AMENDMENTS TO DRAWINGS

ANNOTATED MARKED-UP COPY

Fig. 1

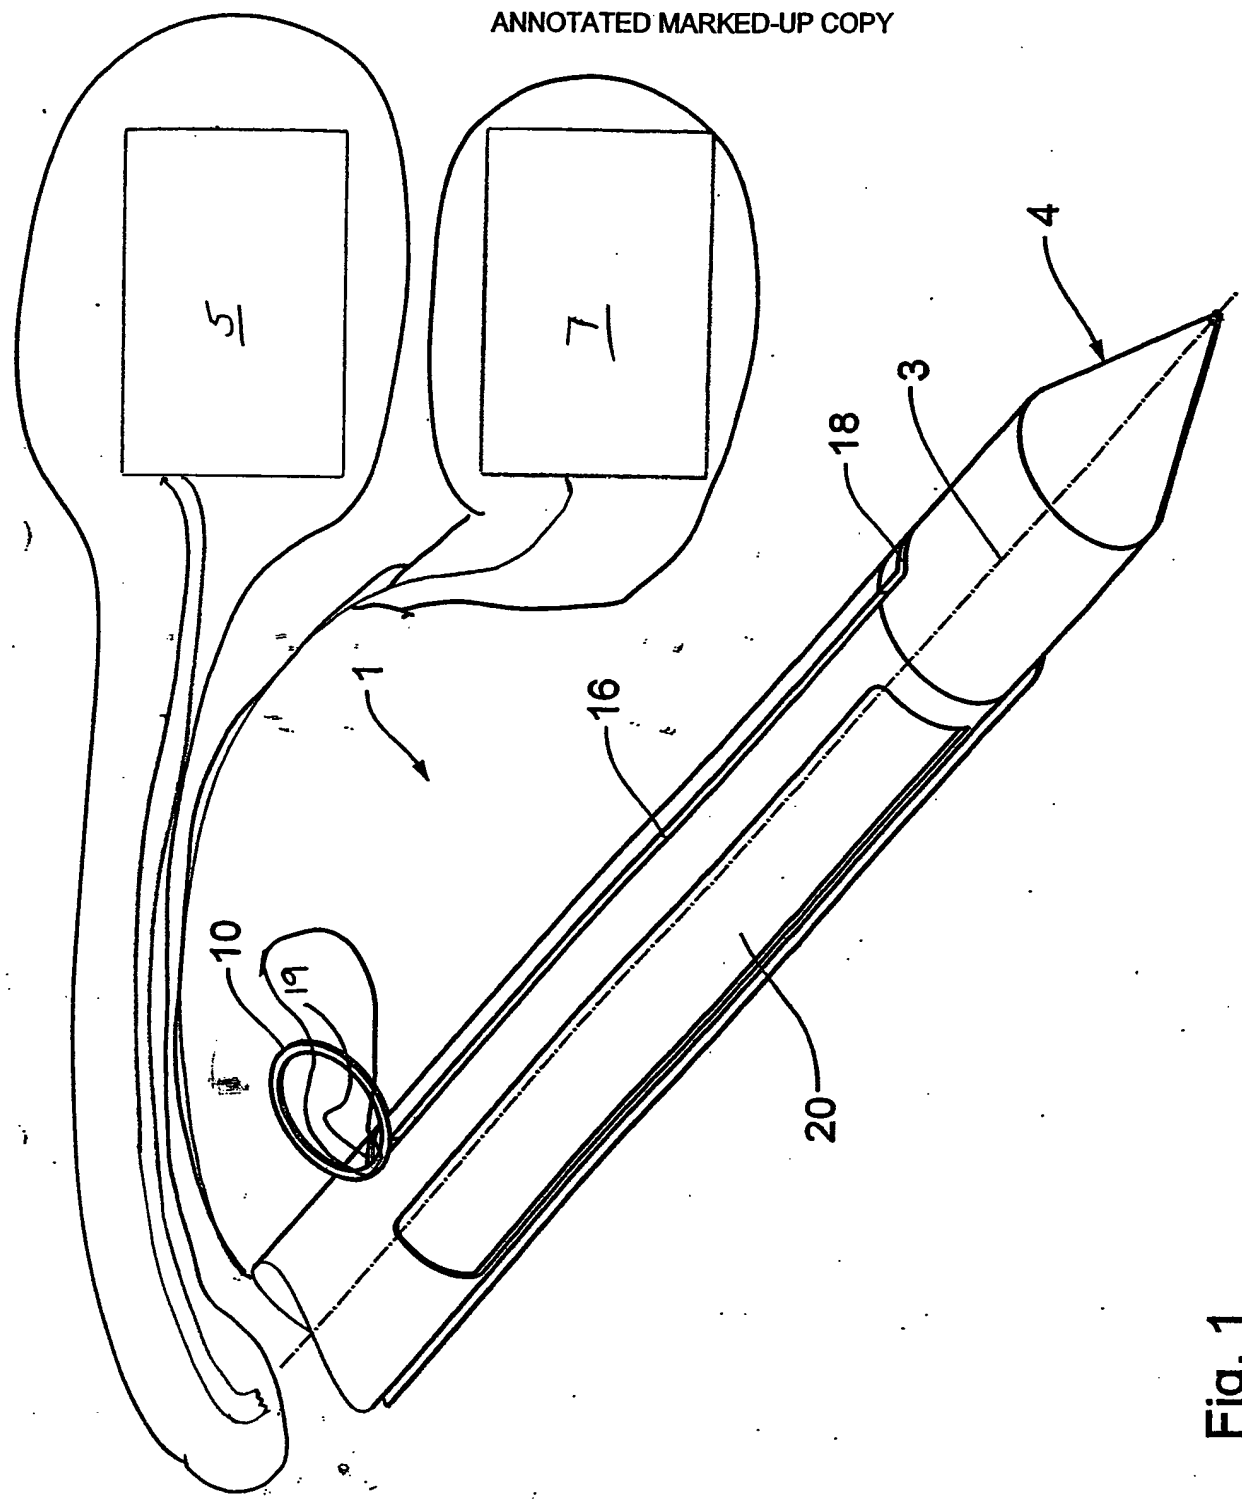
The Applicant amends FIG. 1, as indicated on the enclosed Replacement Page to add a reference numeral for the gap 19; add a schematic illustration of the vacuum or suction device 5; and add a schematic illustration of an HF voltage source 7. The enclosed Annotated Marked-Up Copy indicates the changes in red.

The Examiner has objected to the drawings for failing to show elements recited in the claims. The Applicant submits proposed changes to FIG. 1. FIG. 1 is altered in three respects: 1) a reference number 19 is added to call out the "gap" recited in claim 12; and 2) a suction device 5 is added; and 3) an HF voltage source 7 (recited in claim 18) is added. The suction device and the HF voltage source are illustrated schematically. The specification as originally filed described the suction device and the HF voltage source.

It is noted that the gap 19 itself was present in the drawings as filed; the modification here is simply to add a reference numeral.
